Docket Item # 11  
BAR CASE # 2008-0059

BAR Meeting  
May 21, 2008

**ISSUE:** Alterations

**LOCATION:** 105 King Street

Figure 1. Existing storefront, 105 King Street.

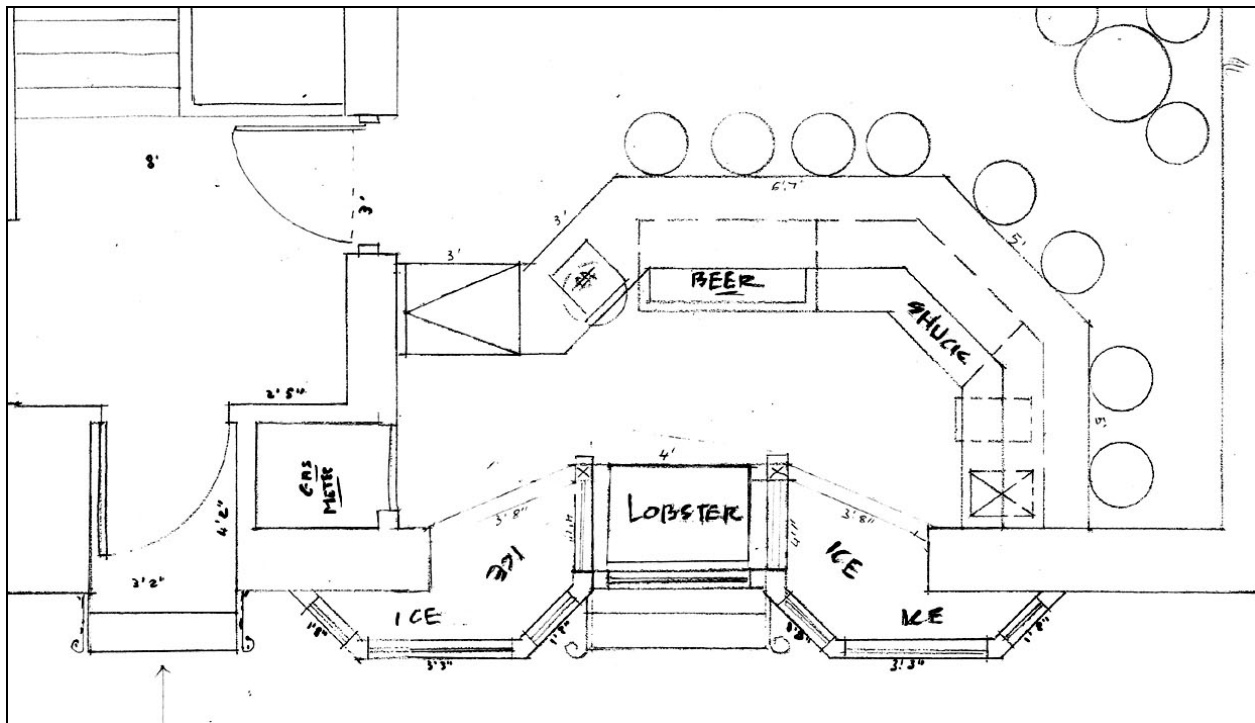
The applicant is requesting approval of a Certificate of Appropriateness for the relocation of the entrance door in the storefront of 105 King Street. The applicant proposes to move the existing door forward to the building line, flush with the rear portion of the show windows. The existing metal railing and steps will remain. The applicant proposes to install a moveable lobster tank in the interior of the building in what was the entrance alcove. The applicant proposes to retain the partitions framing the former alcove in the newly-created interior space.

The applicant has met with Staff regarding the proposed alteration. The proposed alteration will continue to allow this first floor area to be read as a storefront with projecting show windows and a defined entrance. Although the applicant proposes to no longer use this entryway as a means of access, it will continue to have a door. In addition, the applicant indicates that the existing partitions of the storefront in the interior will remain. The proposed alterations are reversible and will not permanently alter historic fabric on this building.

- R-1 Deny. Application is significant change to historic streetscape façade and entryway.

1. The applicant shall maintain the existing show window partitions that will now be interior features, and reuse the existing door.
